ZS 2012-0212

Zion Nuclear Power Station, Units 1 and 2
Facility Operating License Nos. DPR-39 and DPR-48
NRC Docket Nos. 50-295 and 50-304

Subject: Request for Amendment to Approve Methods of Analysis, use of the Upgraded Fuel Handling Building Crane System as a Single-Failure Proof Crane and Approval of a NUREG 0612 Compliant Heavy Loads Handling Program

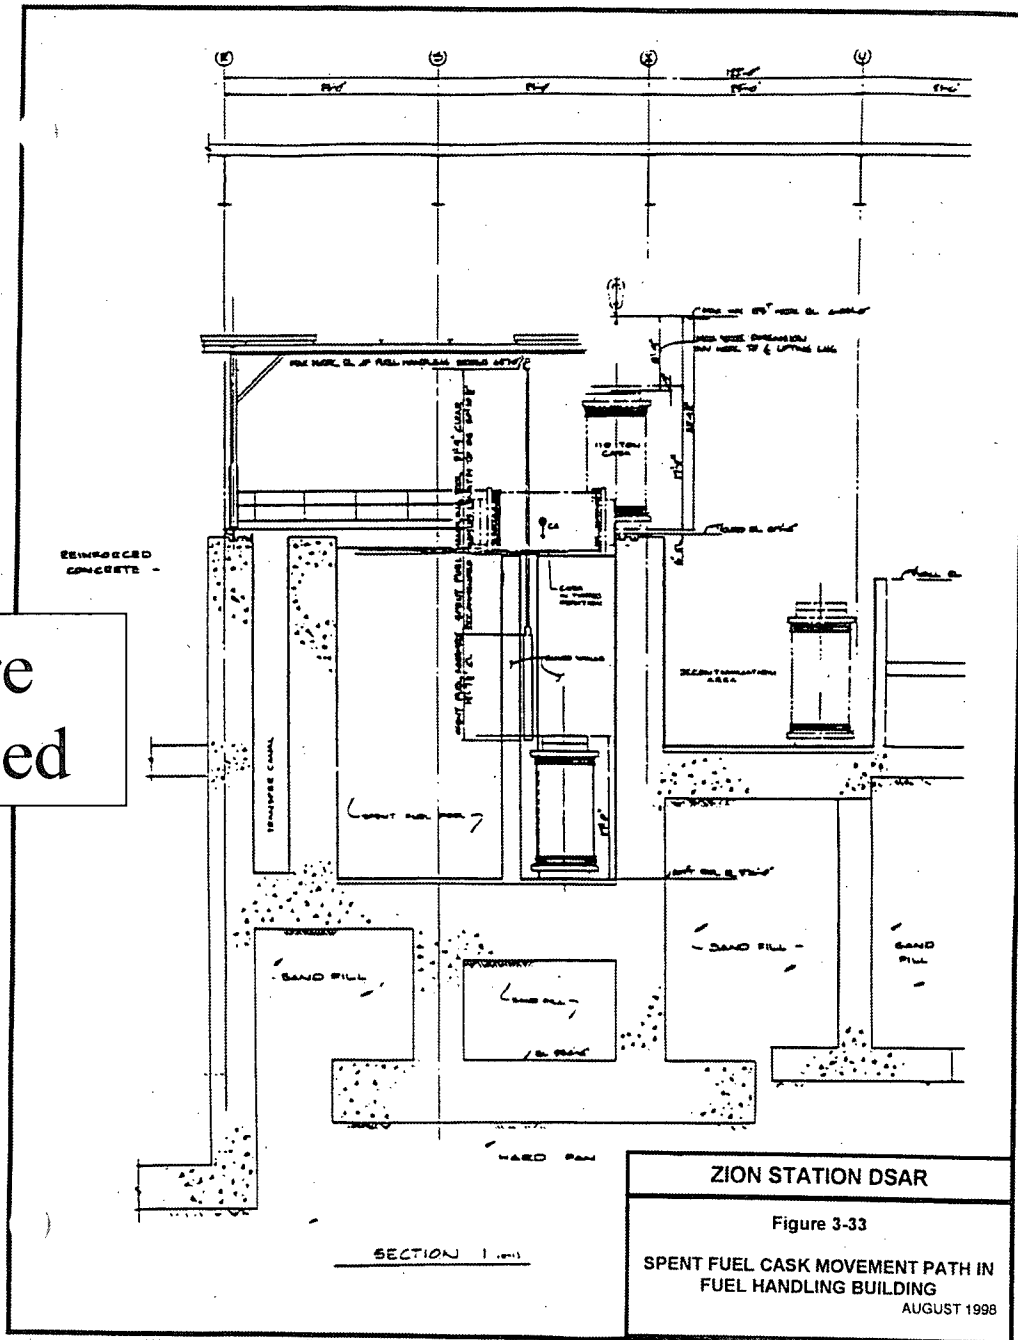
Figure
Deleted

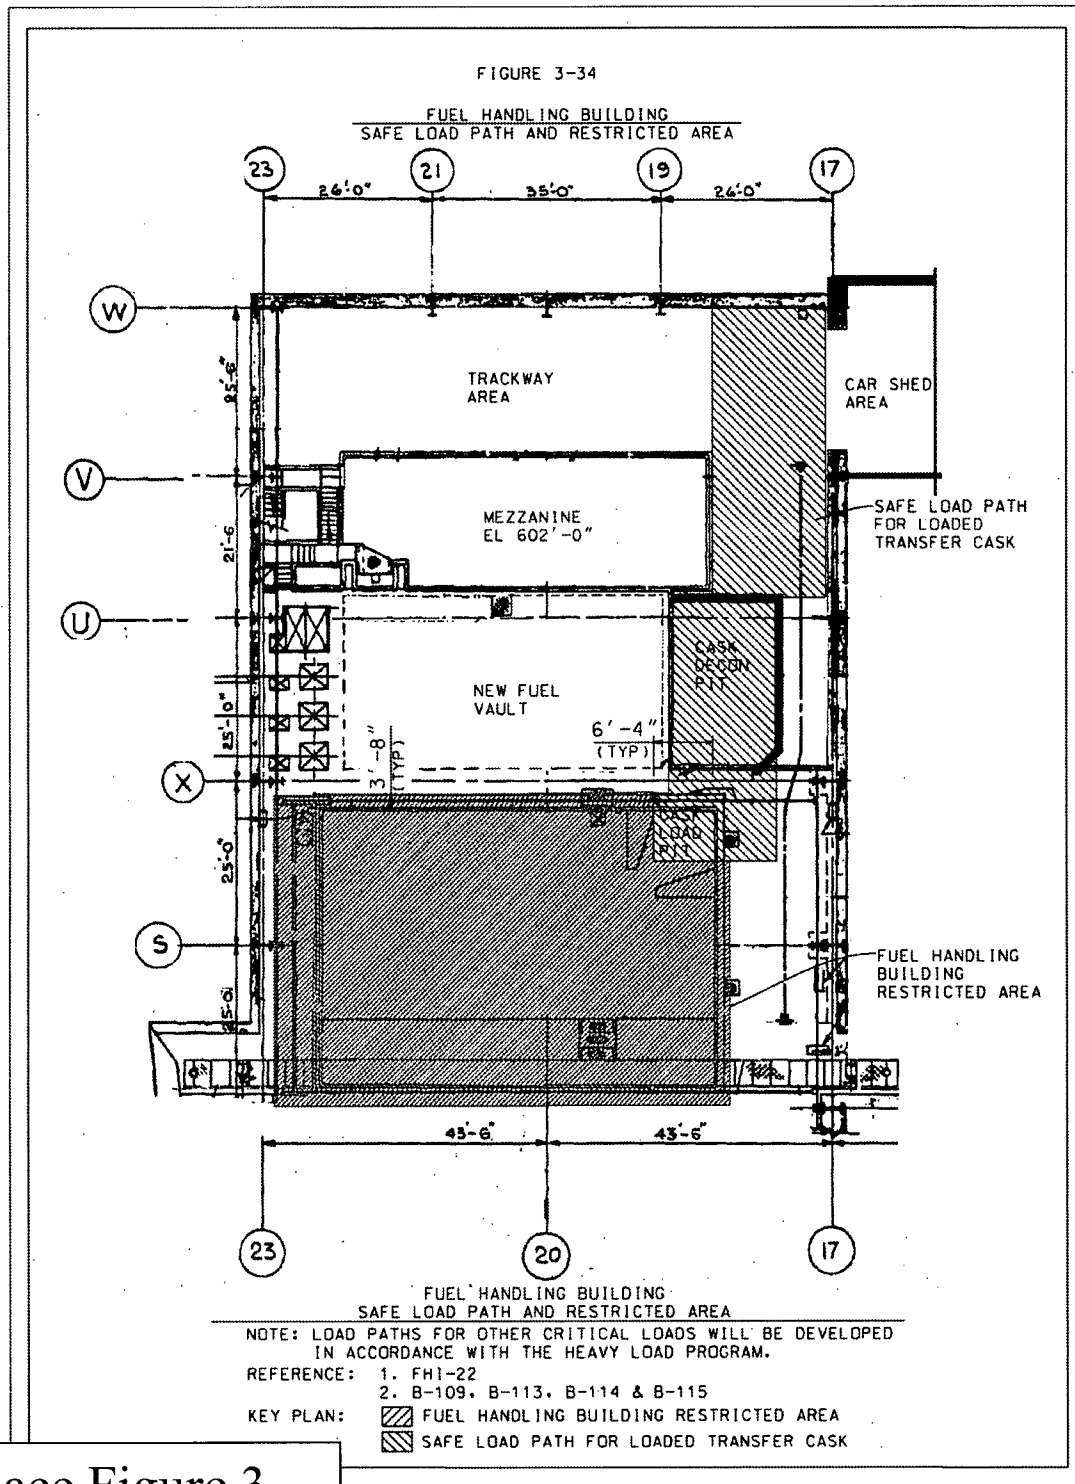
Replace Figure 3-34 in the DSAR with this Figure

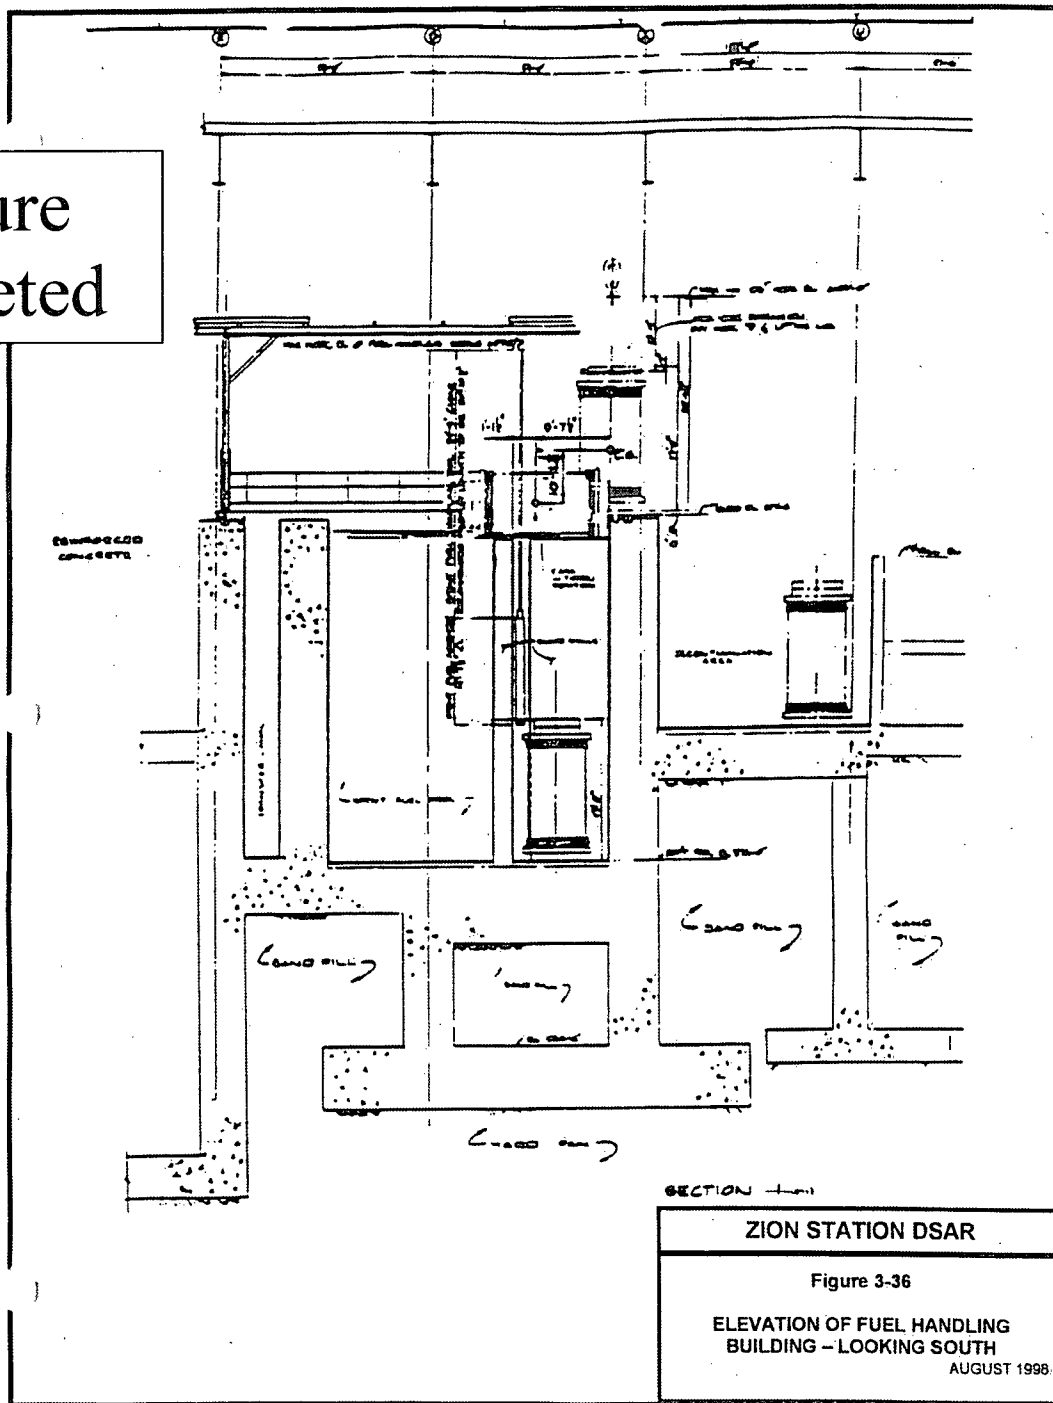
Figure
Deleted
